STAFF REPORT
WEST ALLIS PLAN COMMISSION
Wednesday, February 22, 2023
6:00 PM

6. Site, Landscaping, and Architectural Design Review for Joya Zam, a proposed Neighborhood Retail use, at 9611 W. Greenfield Ave. (Tax Key No. 450-0104-000).

Site & Landscaping Plan

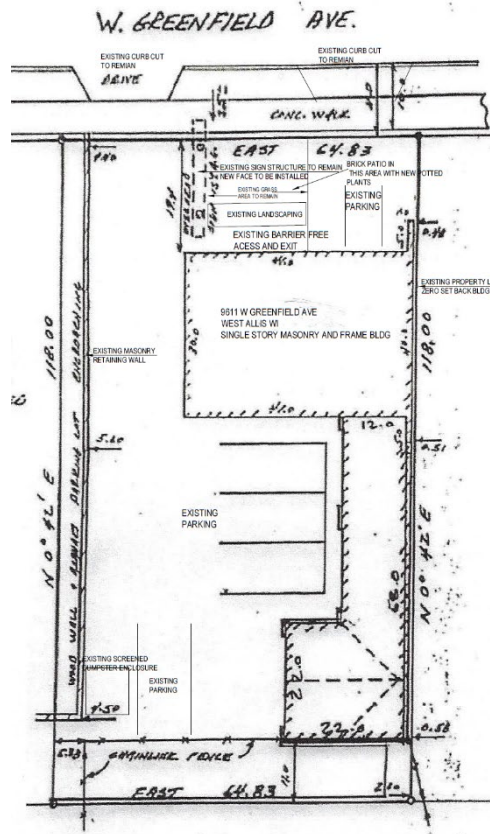
Several changes to the site are proposed. Engineering and Planning are requiring vacation of the existing curb cut on Greenfield Avenue to eliminate traffic safety concerns. Abutting W. Greenfield Ave. is a concrete pad that was previously used as a parking stall. This parking stall will be eliminated during the curb cut vacation process. Pedestrian access is provided by the concrete pad on the front of the property. The existing refuse enclosure on the site is to remain unchanged.

The owner intends to utilize the existing non-conforming pole sign on the property. The existing non-conforming pole sign shall remain so if no other signage is utilized on the property. Upon request of additional signage, the existing non-conforming freestanding sign is required to be replaced.

Five existing parking stalls are proposed to be utilized on the site. Per Code, a maximum of three stalls per 1,000 sq ft of gross floor area open to the public is allowed. While the number of stalls is below the maximum number of stalls allowed, staff is requesting the parking stall furthest south to be eliminated to prevent internal traffic conflicts between other customers and the proposed interior employee parking. Additionally, the traffic stall on the concrete pad abutting Greenfield Ave is to be removed as well.

No landscaping plan was provided. The applicant expressed intent to remove existing landscaping on the property. Any changes to the landscaping on the property require a landscape plan to be submitted. To increase the design review guidelines emphasis on enhancing the public realm, staff recommends that subtle public amenities are incorporated to the site. This may take place in the form of benches and planters. Additionally, the parking pad may be replaced for additional landscaping to be implemented.

1. Revised site and landscaping plan being submitted to the Planning and Zoning Office to indicate the following:
 - a. Notation on the site plan to indicate removal of the parking stall on the south edge of the property and the parking stall on the concrete pad abutting Greenfield Ave.

- b. Notation on the site plan to indicate the vacation of the curb cut along Greenfield Ave.
 - c. Any additions or changes to the landscaping plan being approved by the City Forester.

Architectural Plan

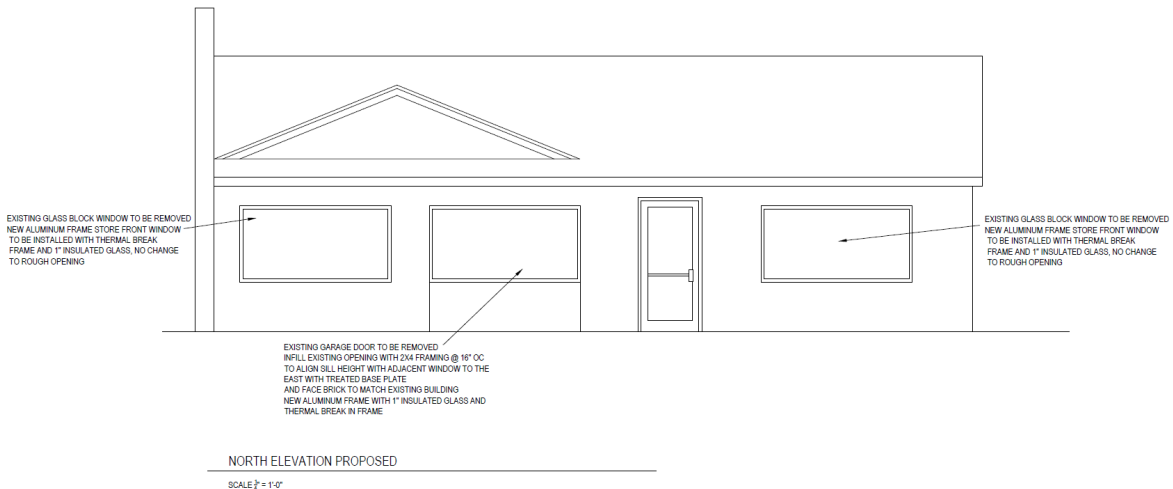
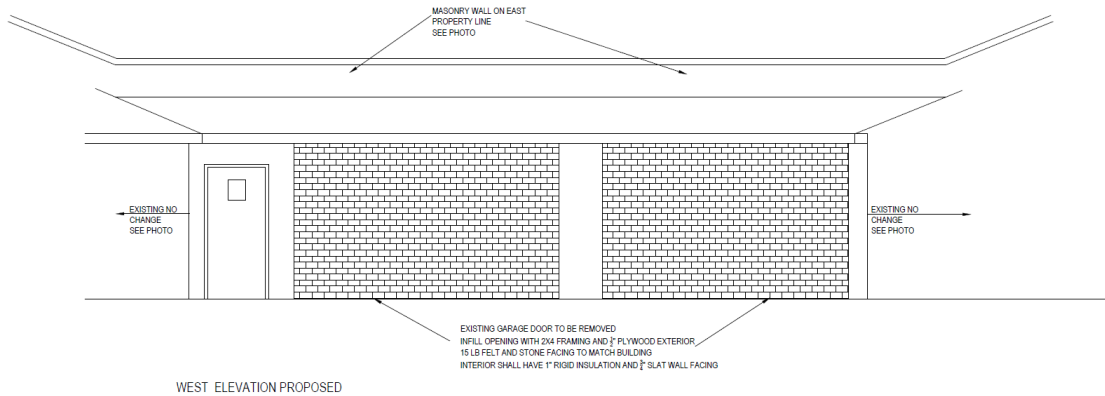
Numerous architectural changes are proposed for the building, largely on the west and north façades. Currently the north, front-facing façade has two glass block windows, an overhead garage door, and a door entrance for customers. As proposed, the existing block windows on the front facing façade are to be removed and replaced with standard storefront windows. Additionally, the overhead garage door is to be removed. Replacing the overhead door is a new knee wall and a window aligned with the existing adjacent windows on the façade. No other changes to the front façade are proposed.

Currently on the west elevation are three overhead garage doors, three rear access doors, and two glass block windows. Two of the overhead garage doors are proposed to be removed. The garage doors are to be replaced with stone to match the existing materials on the west façade. The other garage door on the southwest corner is to remain. The proposal does not include replacement of the existing glass block windows on the southwest façade. Due to visibility along Greenfield Ave and to ensure conformance with the Design Review Guidelines, staff is recommending these windows are replaced with standard storefront windows matching the adjacent windows on the front façade. No façade changes are proposed on the east and south elevations.

2. Revised architectural plan being submitted to the Planning and Zoning Office to indicate the following:
 - a. Removal and replacement of the glass block windows on the west façade to match the proposed adjacent windows on the front façade of the existing building.

Floor Plan:

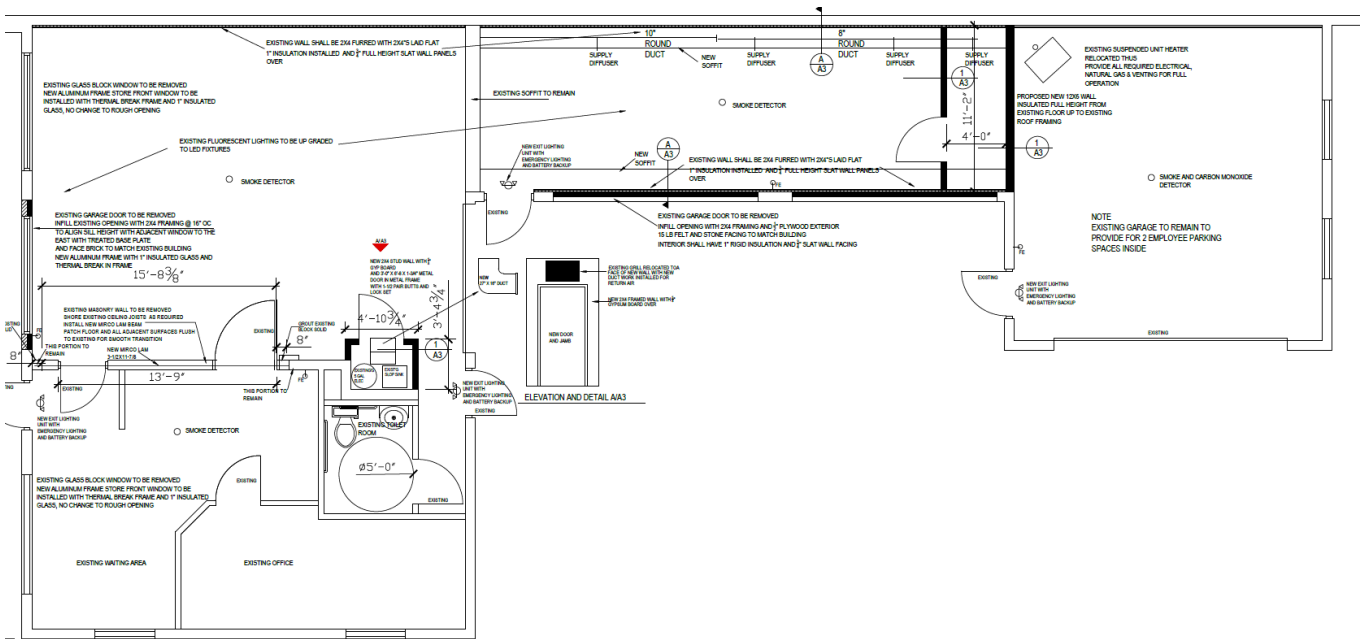
The interior of the building also sees additional investment and changes. Additional areas will be open to the public in the building, with jewelry cases lining the east interior wall. New LED lighting will replace the existing fluorescent lighting. The existing office, restroom, and waiting area are to remain unchanged. A new interior wall will be placed to form a garage on the south portion of the building. The garage will be used for interior employee parking.
